NSLPP MEETING HELD ON 29/09/21

ADDRESS/WARD: 153 & 157 Walker Street, North Sydney (W)

PROPOSAL NO: 4/21

AUTHOR: Ben Boyd, Executive Strategic Planner

FIGURE 7: Extract of the Structure Plan

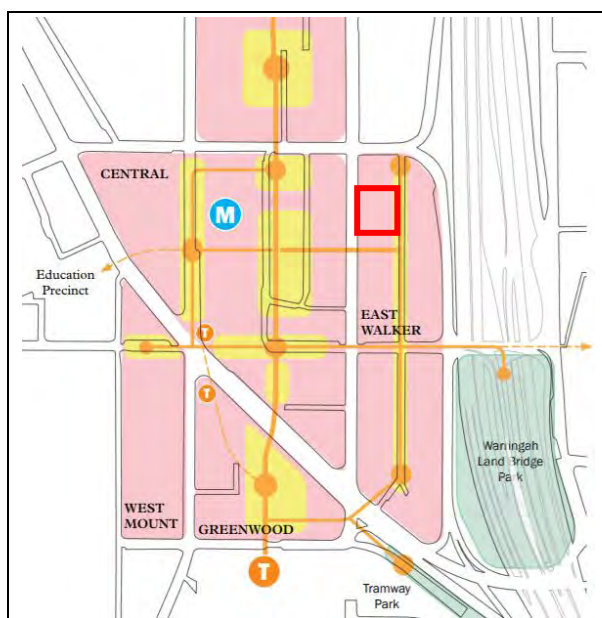
The PDS identifies the subject site as being located within the *East Walker Urban Block* and seeks to prioritise the pedestrianisation of Little Walker Street, being identified as an “inner block space” and will ultimately provide an important future north-south pedestrian route. It also identifies a desire to improve east-west pedestrian connections from Miller Street through to Little Walker Street between Berry and Mount Streets. The PDS envisages that the through site link to be created between Walker and Little Walker Street will be a natural extension to the current existing through site link to the west of Walker Street connecting through to the Victoria Cross Metro Station.

FIGURE 8: Extract of the Detailed Plan for Little Walker Street

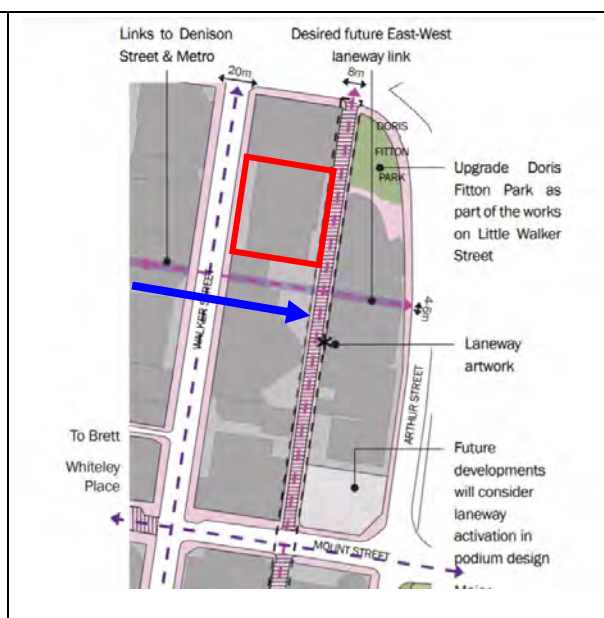
The thick blue arrow shows the actual alignment of the existing link to the west, suggesting that link should be further to the south.
